TECHNICAL BULLETIN

POINT BLANK 2

Two problems have been identified on games with the following serial numbers:-

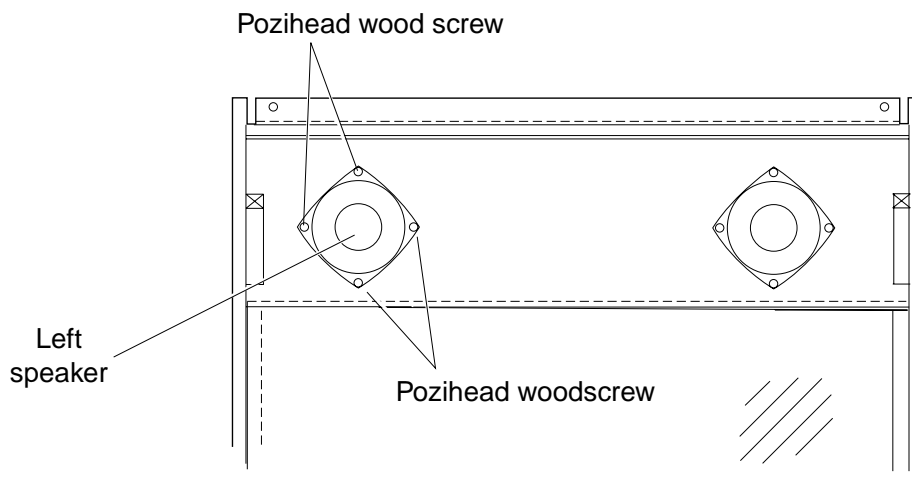
1. **SWITCH THE GAME OFF.**
2. Remove 5 off security screw (M5x20) and remove the speaker mesh.

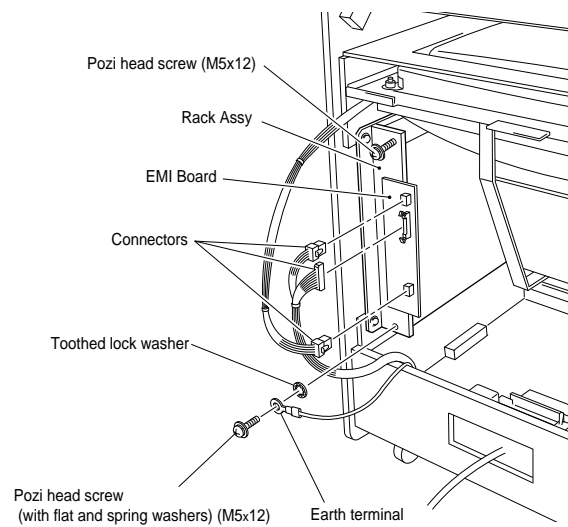
3. Remove 4 off pozi head wood screws and remove the left speaker only sufficiently to access the speaker connections.
Note: Take care not to damage the speaker cone.

4. Disconnect the speaker.
5. Cut off the 0.110" (smallest) receptacle from the white/violet wire and replace it with the supplied 0.187" receptacle.
6. Cut off the 0.187" receptacle from the white/red wire and replace it with the supplied 0.110" receptacle.
7. Reconnect the speaker and reassemble in reverse order.

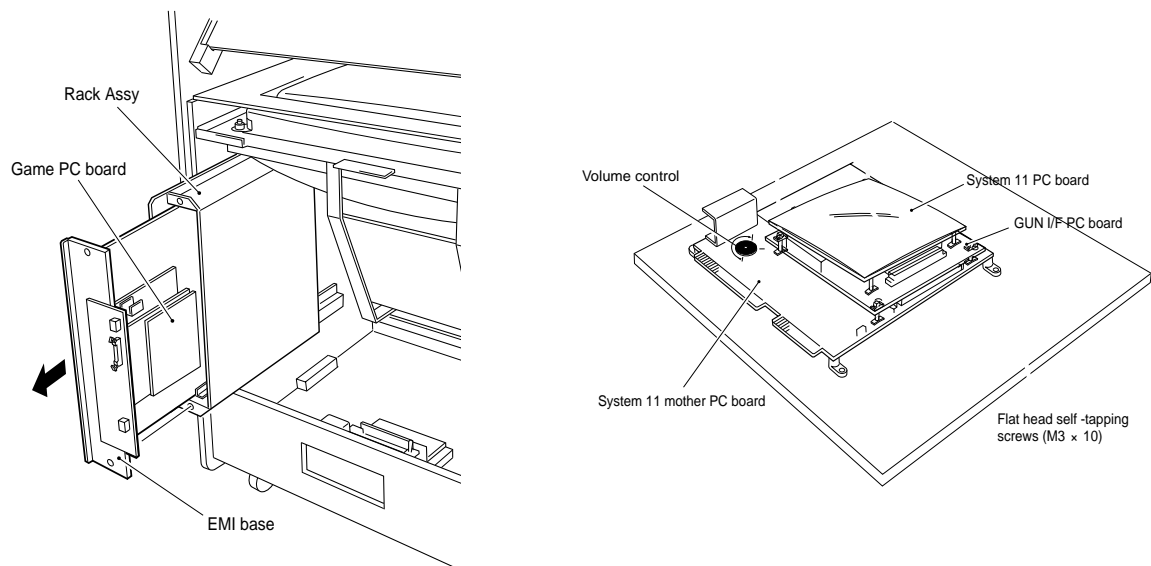
8. Open the back door and disconnect the connectors from the EMI Board.
9. Remove 2 off pozi head screws (M5x12) from the rack assembly, taking care not to lose the toothed washer behind the earth terminal.

10. Carefully withdraw the game pcb assembly from the rack assembly only sufficient to gain access to the volume control on the System 11 Mother PC Board.

11. Turn the volume control clockwise to approx $\frac{3}{4}$ of its travel.
12. Ensure that the System 11 Mother PC Board edge connection is fully seated in the edge connector housing of the EMI PC Board and reassemble in reverse order.
